Re: Minor Project Refinement No. 8 for the South Orange County Reliability Enhancement Project.

South Orange County Reliability Enhancement Project CPUC Minor Project Refinement Form

Report No.: 8

SOCRE PROJECT
MPR-8 Location 18 & 19
San Juan Capistrano
Orange County, CA

View of approximate locations of anchors in relation to poles 18 & 19, facing N. See following Photos 1 and 2 for close-up images of proposed temporary disturbance areas.

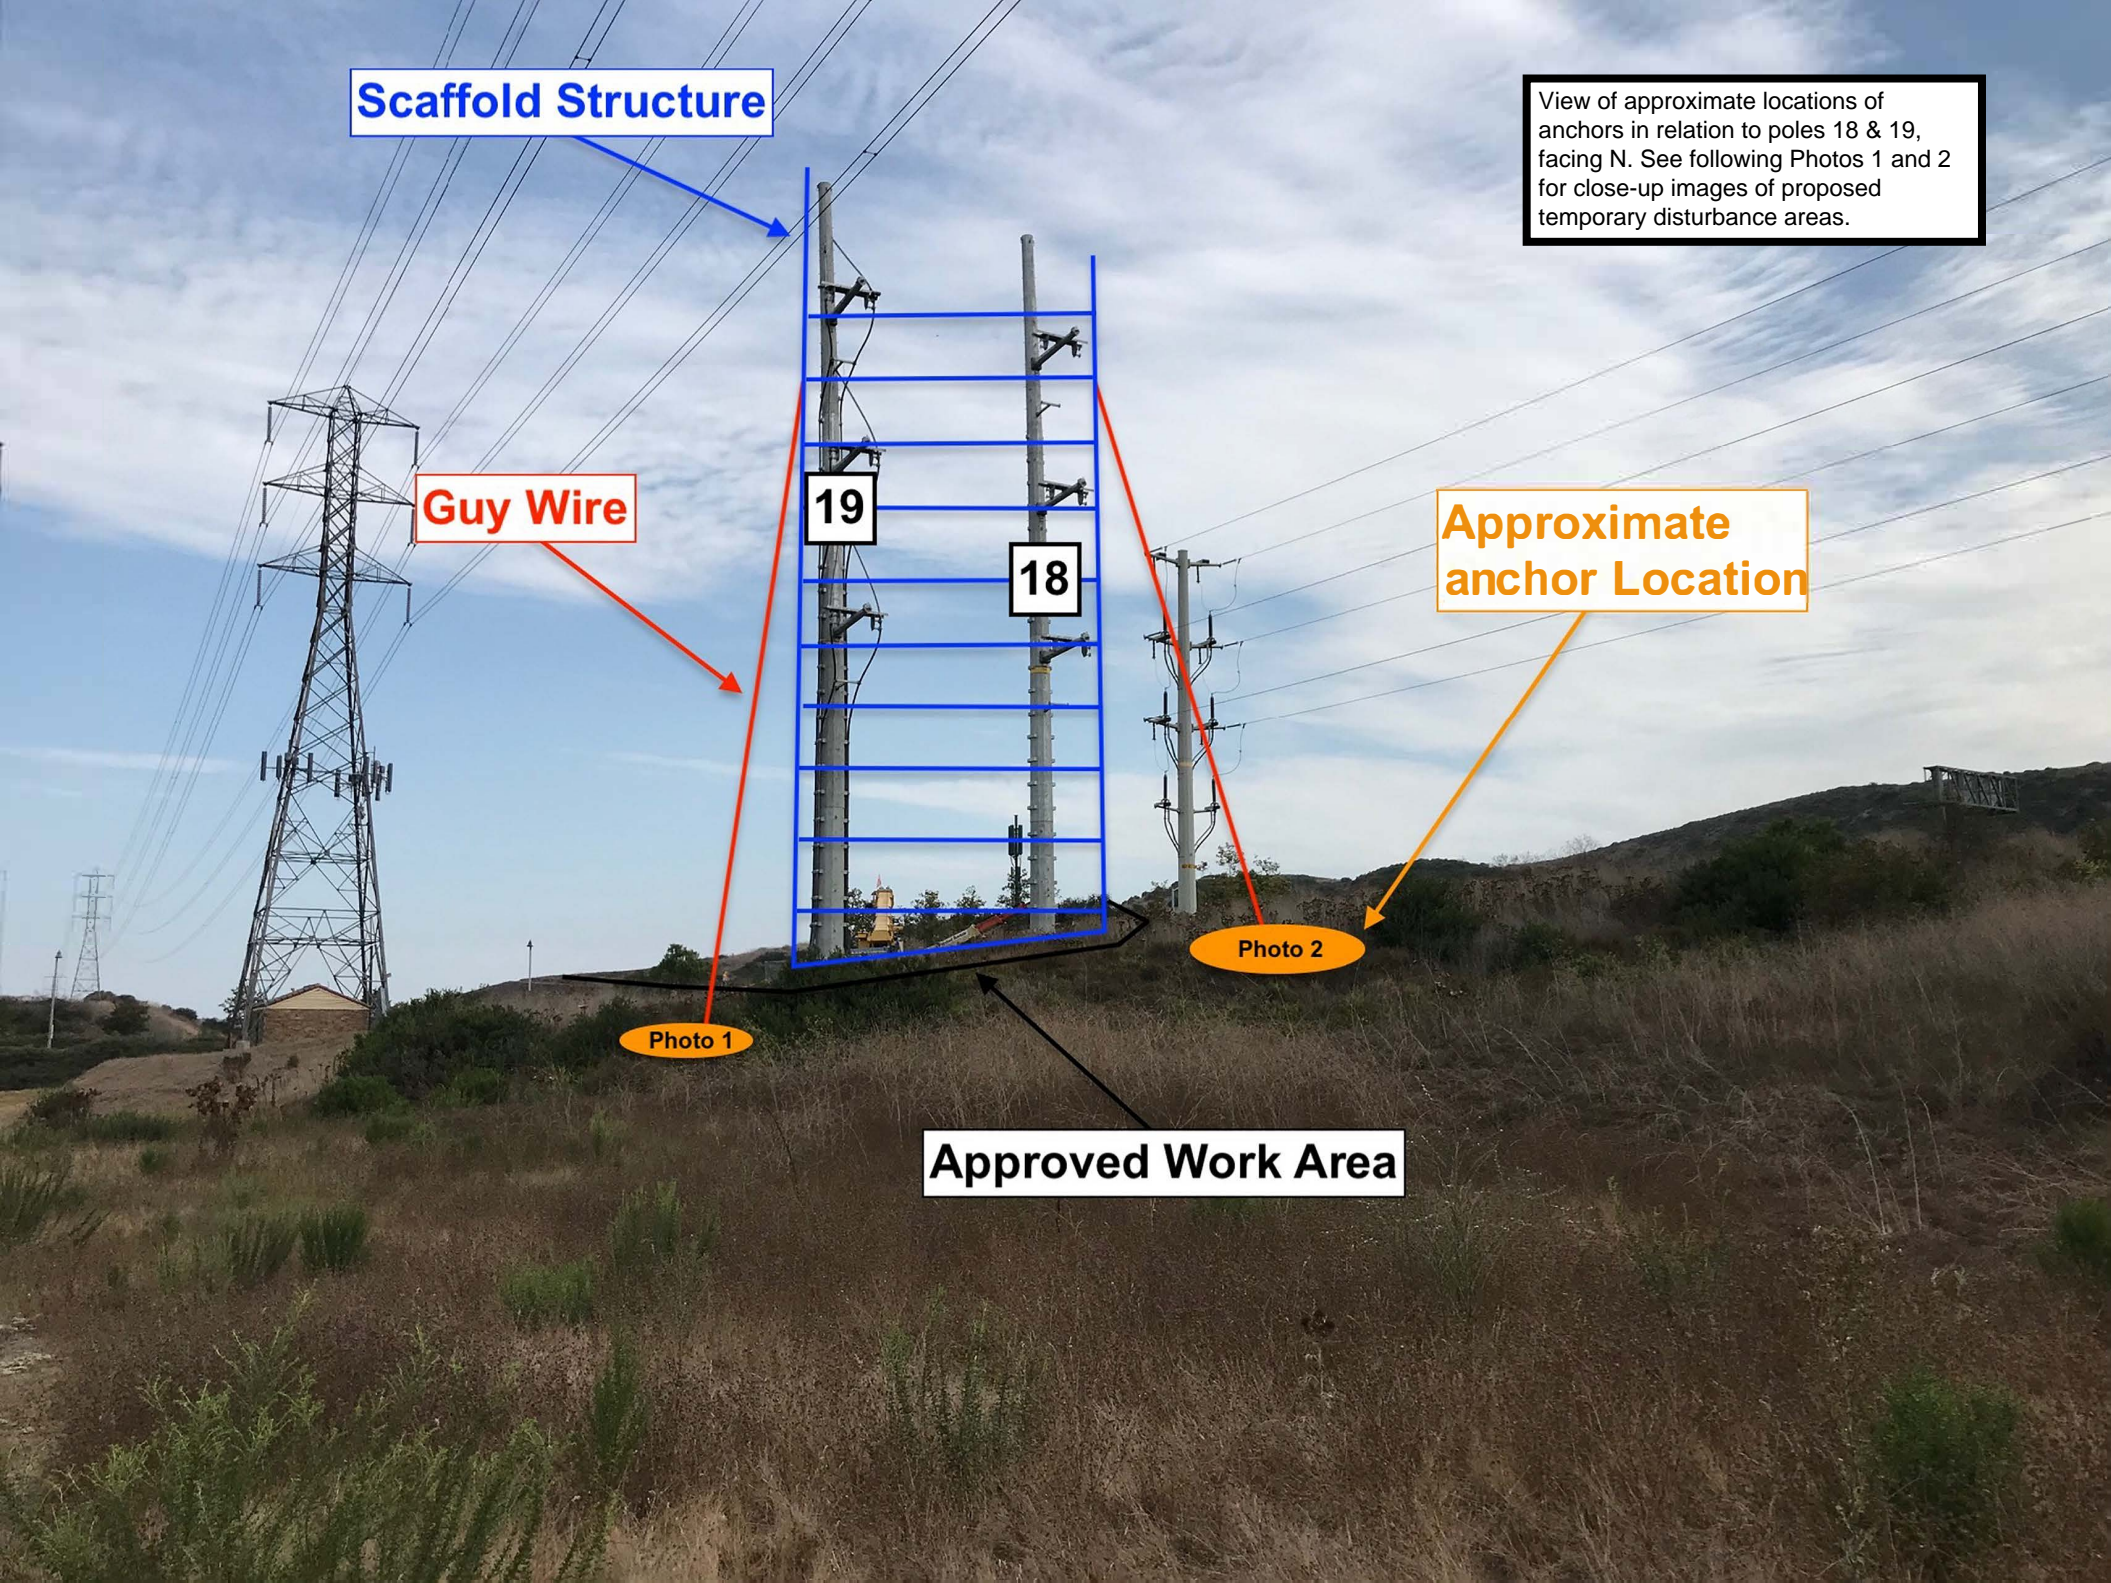
Approximate anchor Location

Photo 1

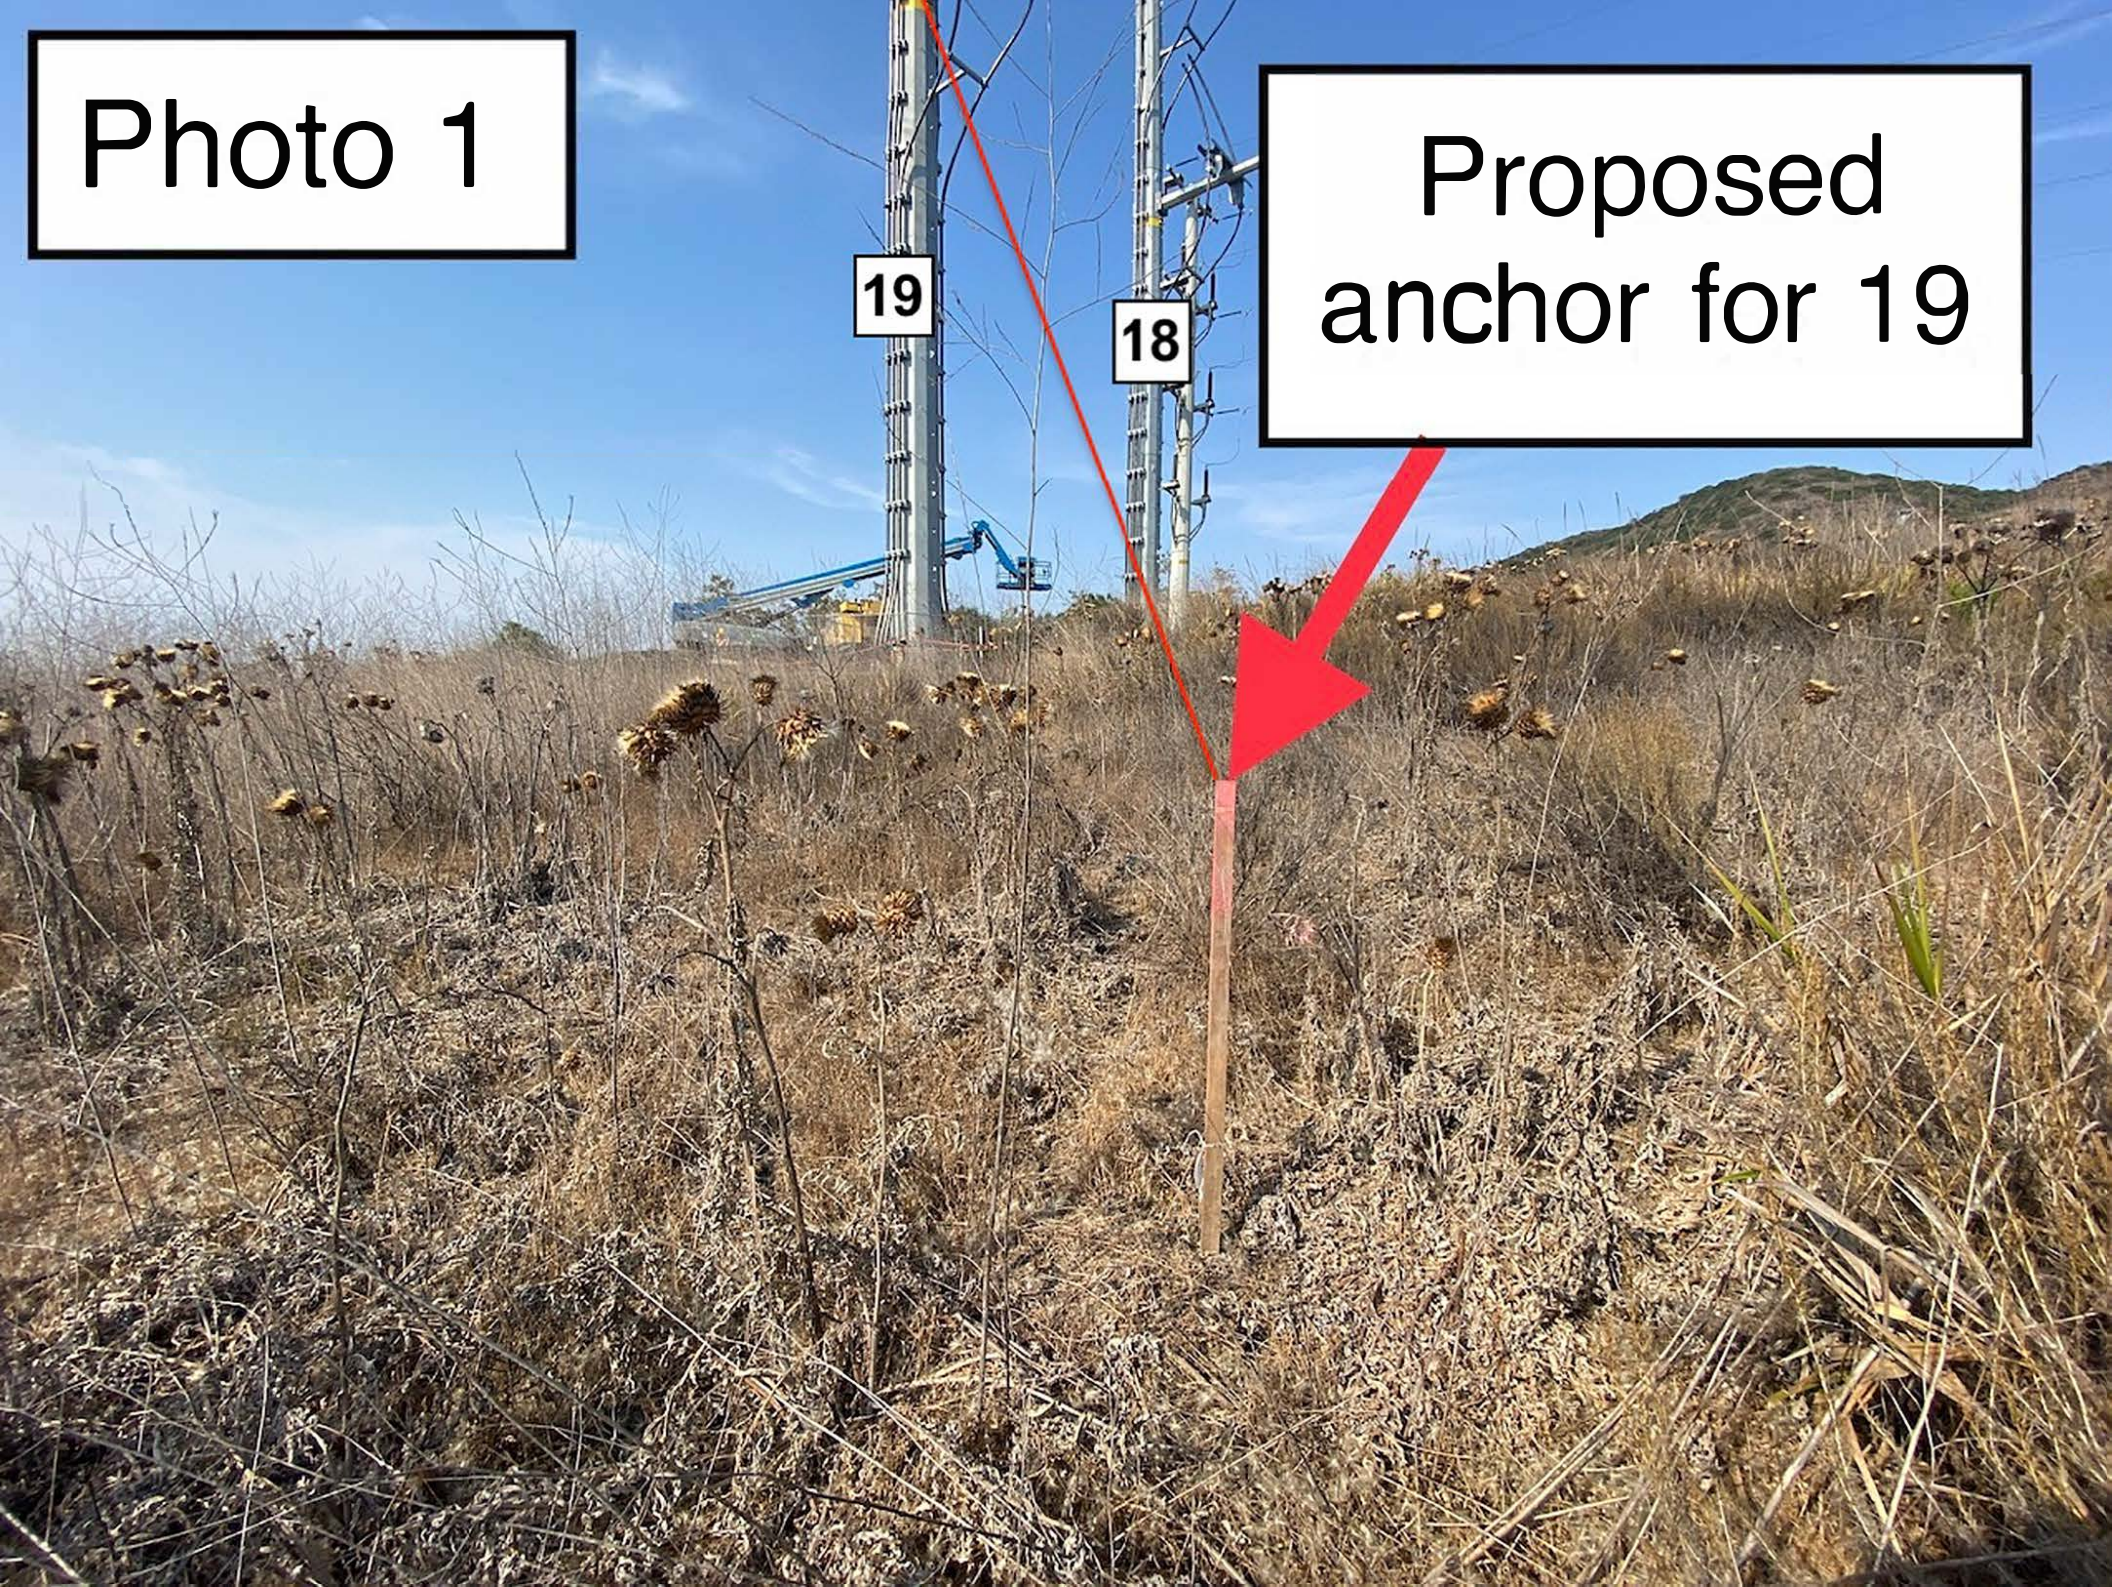
Proposed
anchor for 19
